Service Bulletin

SB-10059103-5473

SUBJECT: Service Update for Inventory and Customer Vehicles
Body Wire Harness Chafe
Expires with Base Warranty

MODELS: 2015 Chevrolet Colorado
2015 GMC Canyon

4147560

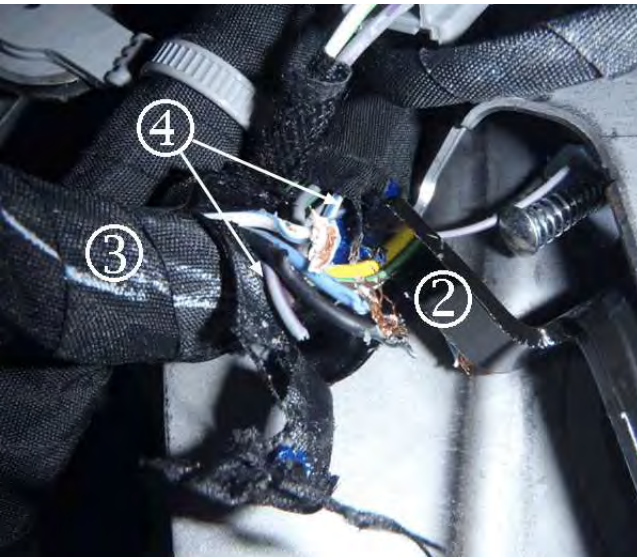
Photograph shows a damaged (4) body wire harness. Note the contact between the park brake pedal assembly switch activating tab (2) and the body wire harness (3).

2. Locate the park brake pedal assembly switch activating tab (2) and body wire harness (3).
3. Using a flash light determine if the body wire harness has been damaged (4) by park brake pedal switch activating tab.

- If the body wire harness (3) is chafed and damaged (4) by the park brake pedal assembly switch activating tab (2), proceed to step 4.
 - If the body wire harness is NOT chafed and damaged by the park brake pedal assembly switch activating tab, proceed to step 8.
4. Remove tape from body wire harness to gain access to the damaged portion of the body wire harness.

4165682

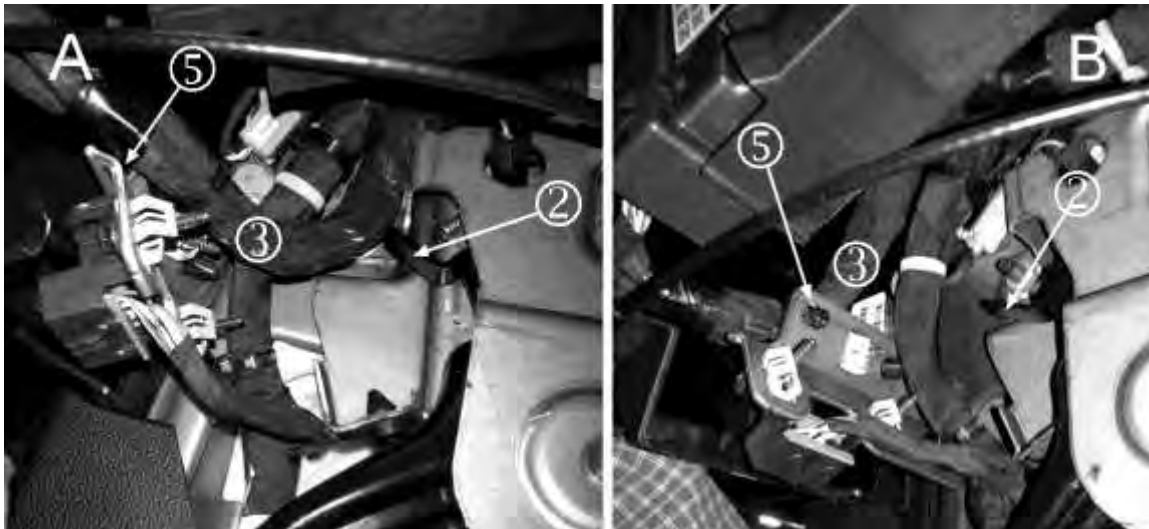
- (A) An incorrectly routed body wire harness. The body wire harness contacts the park brake pedal switch activating tab (2). The body wire harness is mounted on the front side of the bracket.
- (B) A correctly routed body wire harness. The body wire harness does NOT contact the park brake pedal switch activating tab (2). The body wire harness is mounted on the backside of the bracket.
8. Determine if the body wire harness is routed correctly. A correctly routed body wire harness will NOT contact the park brake pedal switch activating tab. In addition, the body wire harness clip on a correctly routed body wire harness is installed on the backside of the mounting bracket.

- If the body wire harness is routed correctly and it does NOT contact the park brake pedal assembly switch activating tab, no further action is required.
 - If the body wire harness is NOT routed correctly and it contacts the park brake pedal assembly switch activating tab, proceed to step 9.
9. Detach the body wire harness from the front side of the bracket and install the body wire harness clip to the backside of the bracket.

10. Ensure the body wire harness is routed correctly and does NOT contact the park brake pedal assembly switch activating tab.
